Youngone (CEPZ) Limited (Extension 2)

Plot 03-06, 09-16, Sector # 2, Chattogram Export Processing Zone
(22.288646, 91.778393)

22 July 2025

Observation-01: Inconsistency in design philosophy between the Construction Drawings and the As-Built Drawings. [Youngone (CEPZ) Ltd. (YCL-5)]

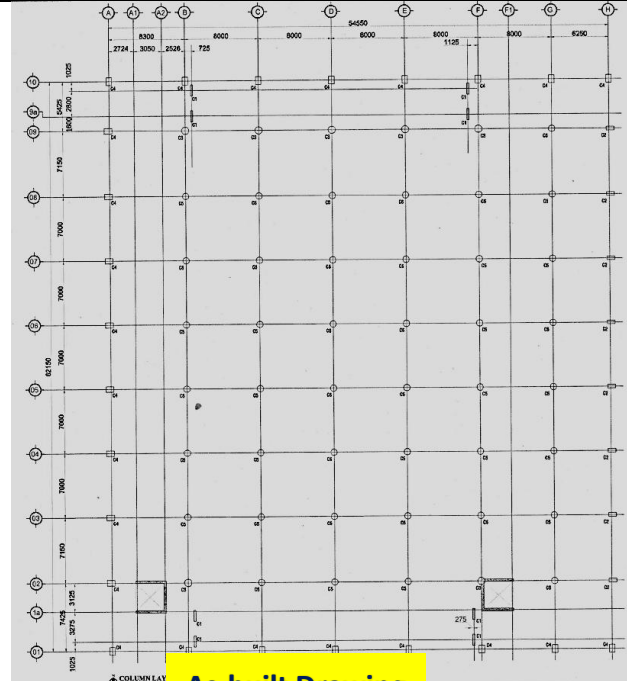
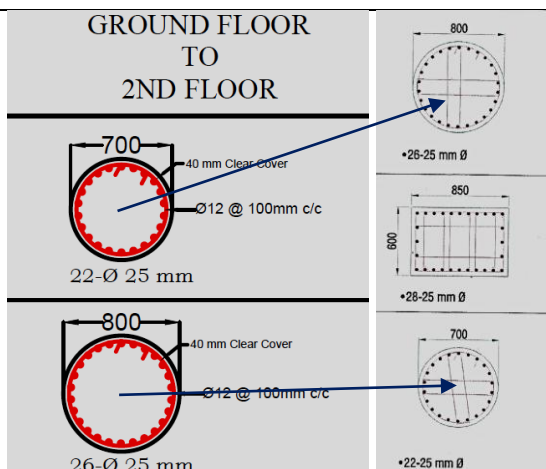
Mismatch in the shear wall layout with the as-built condition

Tie bar missing in the construction drawing

Description: During inspection, the shear wall shown in the construction drawing was missing in the as-built drawing. Additionally, the tie bar arrangement for the circular columns does not match the construction drawing, and the slab thickness also differs from the construction drawing. The building engineer is required to verify the as-built condition, including the pile foundation, through Non-Destructive Testing (NDT).

Building engineer is required to check the design philosophy of the building and confirm the seismic requirements of the building as per BNBC.

Construction drawing

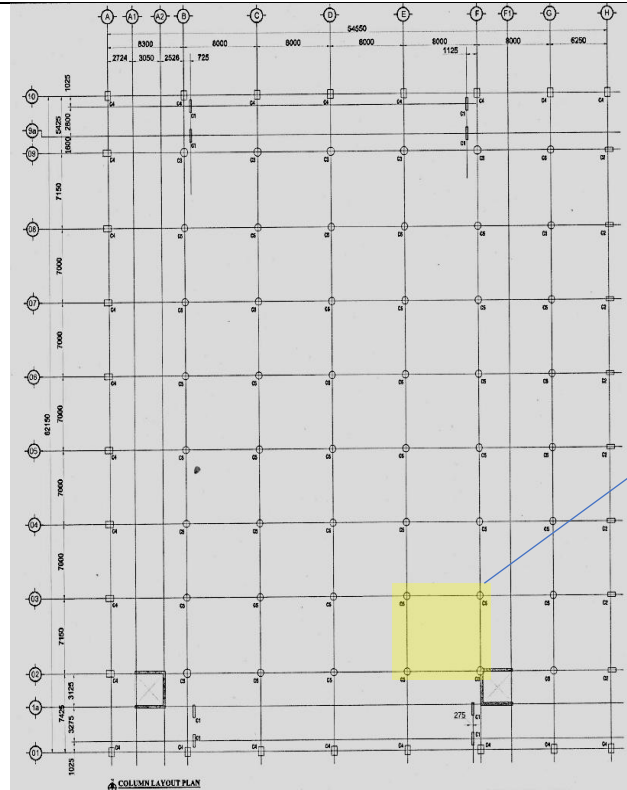
NOTE:- Slab Thickness = **175mm**
A = Ø10mm @ 100mm c/c alt ckd
B = 1 - Ø12mm ext
C = Ø10mm @ 100mm c/c st bar

SLAB THICKNESS = 185 mm

Observation-03: Insufficient concrete strength test reports. [Youngone (CEPZ) Ltd. (YCL-5)]

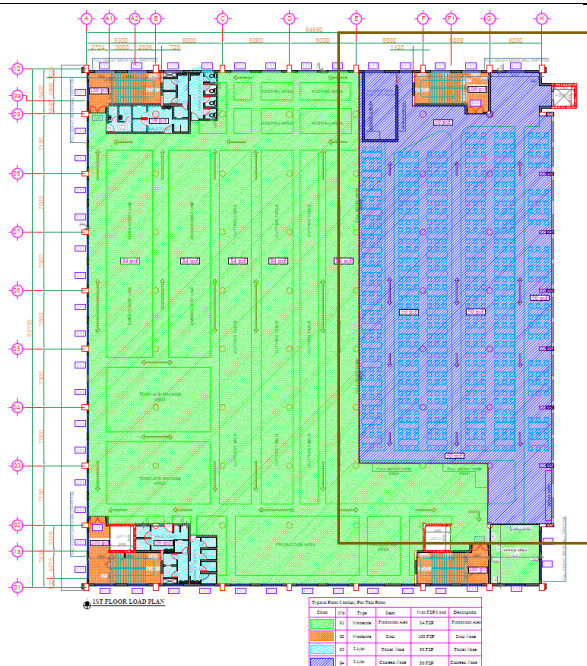
Description: The available test report during the inspection doesn't meet the evaluation & acceptance criteria of BNBC 2020. The building engineer is required to evaluate concrete strength by taking 4 concrete cores from lower-tier columns and 4 cores from beam/slab, as the existing cylinder test data do not meet the requirements of BNBC 5.12.1.

4.		Carry out suggested remedial works where required.	within 6 months
5.	Insufficient concrete strength test reports. [Youngone (CEPZ) Ltd. (YCL-5)]	Verify in-situ concrete strength by taking 4 concrete cores from lower-tier columns and 4 cores from beam/slab, as the existing cylinder test data do not meet the requirements of BNBC 5.12.1	within 6 weeks

Observation-04: Prepared load plan doesn't comply with Table 6.2.3, BNBC 2020. [Youngone (CEPZ) Ltd. (YCL-5)]

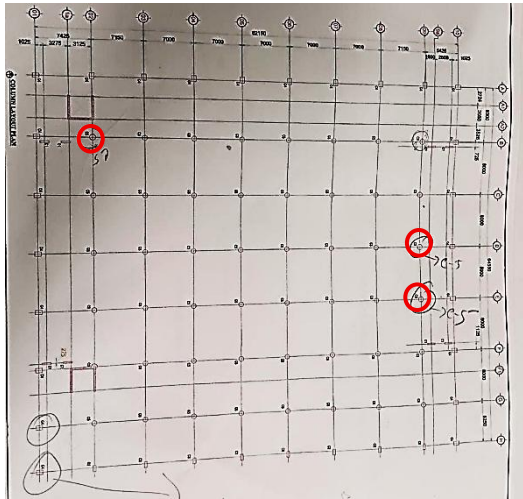
Description: During inspection, the allowable load at the canteen area is considered 50 psf, which doesn't comply with Table 6.2.3, BNBC 2020. Building engineer is required to revise the floor live load plan as per BNBC 2020.

6.	Prepared load plan doesn't comply with Table 6.2.3, BNBC 2020. [Youngone (CEPZ) Ltd. (YCL-5)]	Building engineer is required to revise the floor live load plan as per BNBC 2020. Implement the floor load management plan.	within 6 weeks

Observation-05: Discrepancies in the As-Built Drawings. [Youngone (CEPZ) Ltd. (YCL-5)]

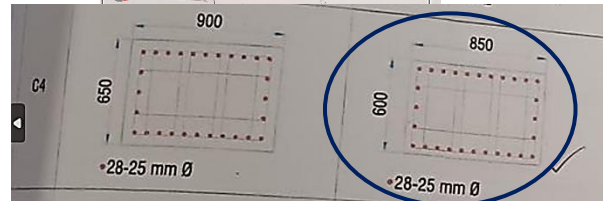
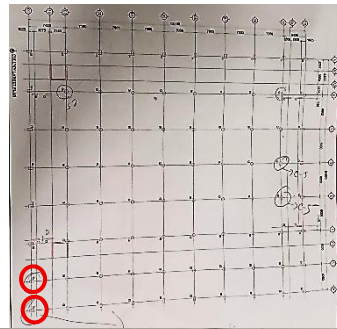
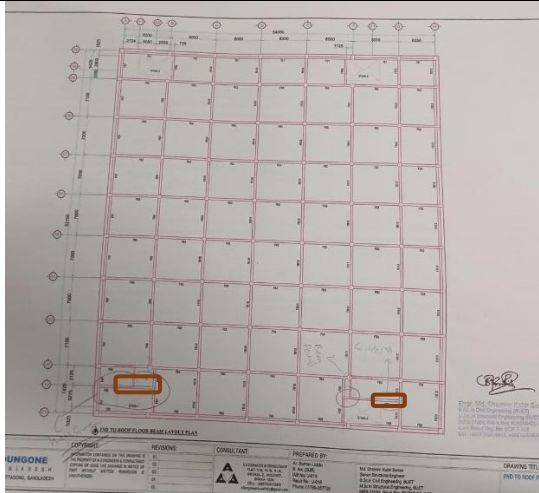
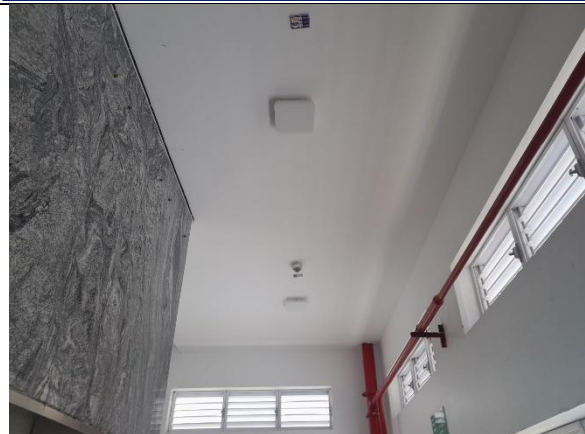
Column Dia. found 700mm instead of 800mm.

20 nos. rebar found instead of 28 nos. (C-4)

Beam missing.

Description: Discrepancies observed in the as-built drawing. Building engineer is required to survey the structure and prepare accurate and detailed as-built drawings.

7.	Discrepancies in the As-Built Drawings. [Youngone (CEPZ) Ltd. (YCL-5)]	Building engineer is required to survey the structure and prepare accurate and detailed as-built drawings.	within 6 weeks

Observation-06: Verification required for the Structural connection and contribution to the lateral load-resisting system of the lift core. [Youngone (CEPZ) Ltd. (YCL-5)]

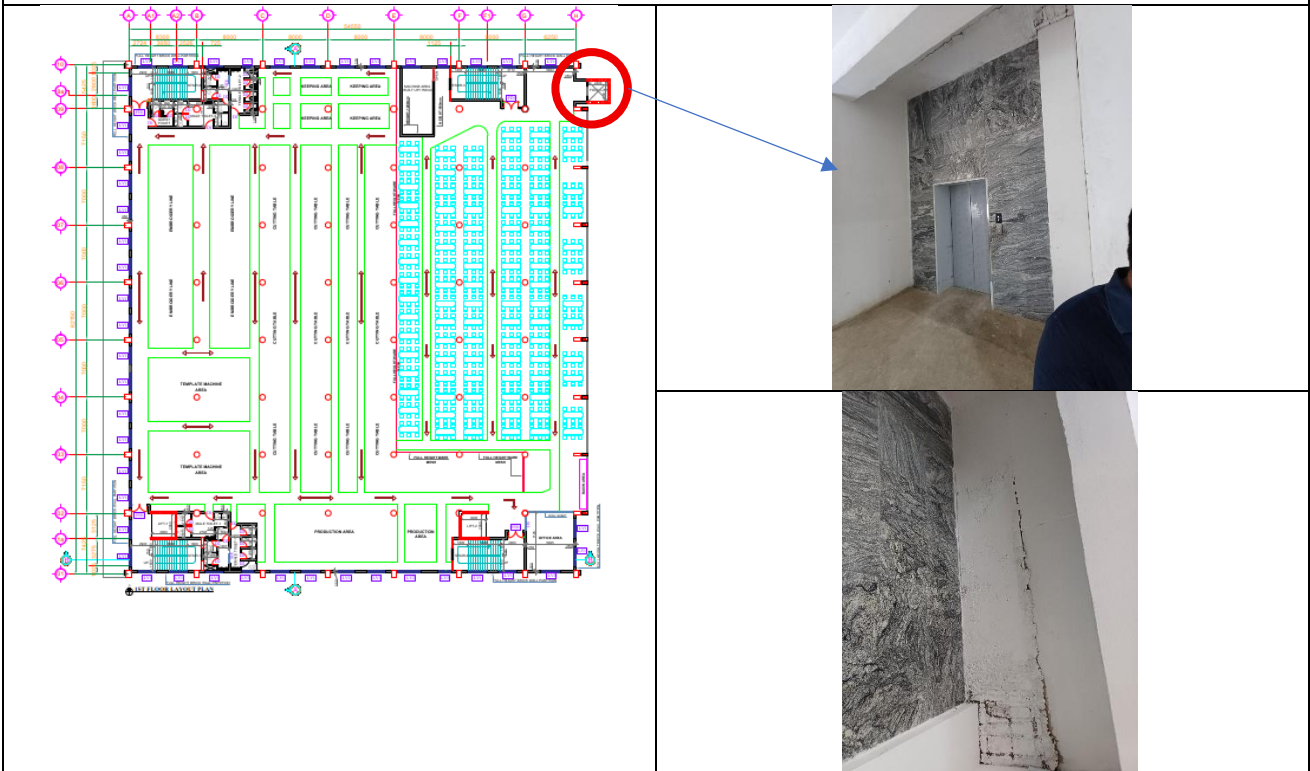
Description: An external lift core was constructed up to the 3rd floor of the building. The structural connection and contribution to the lateral load-resisting system of the lift core is required to be verified. If the building is separated from the building, the building engineer is required to check the lateral stability of the lift core.

8.	Verification required for the Structural connection and contribution to the lateral load-resisting system of the lift core. [Youngone (CEPZ) Ltd. (YCL-5)]	The structural connection and contribution to the lateral load-resisting system of the lift core is required to be verified. If the building is separated from the building, the building engineer is required to check the lateral stability of the lift core.	within 6 weeks

Observation-08: Non-structural elements found unbraced/not anchored. [Youngone (CEPZ) Ltd. (YCL-5)]

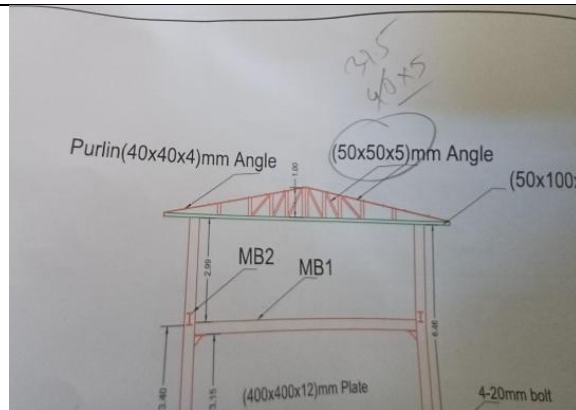
Description: During inspection, non-anchored racking system was found on-site. Building engineer is required to adequately brace or anchor all the non-structural elements.

10.	Non-structural elements found unbraced/not anchored. [Youngone (CEPZ) Ltd. (YCL-5)]	Building engineer is required to adequately brace or anchor all the non-structural elements.	within 6 weeks

Observation-10: Discrepancies in the as-built drawing. (Compressor Shed)

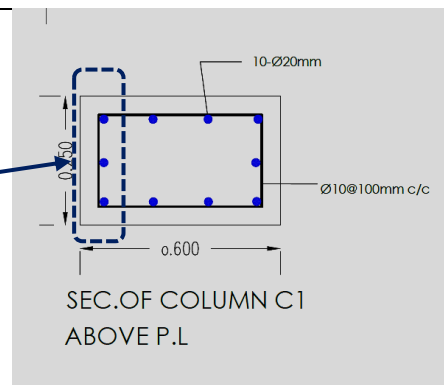
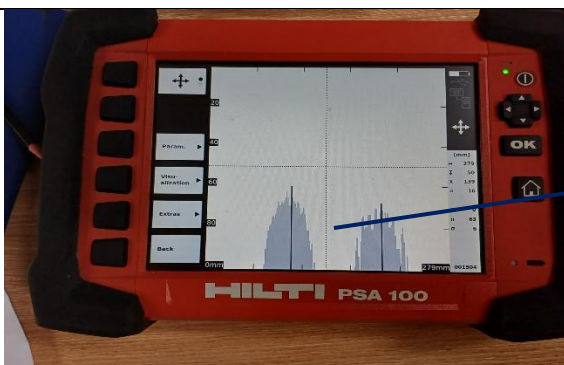
Description: Mismatch found in the as-built drawing, angle size found 37.5mm X 37.5mm X 5mm instead of 50mm X 50mm X 5mm. Additionally, extended north portion was not incorporated in the as-built drawings. Building engineer is required to prepare a detailed and accurate as-built drawing.

12.		Carry out suggested remedial works where required.	within 6 months
13.	Discrepancies in the as-built drawing. (Compressor Shed)	Building engineer is required to survey the structure and prepare accurate and detailed as-built drawings.	within 6 weeks
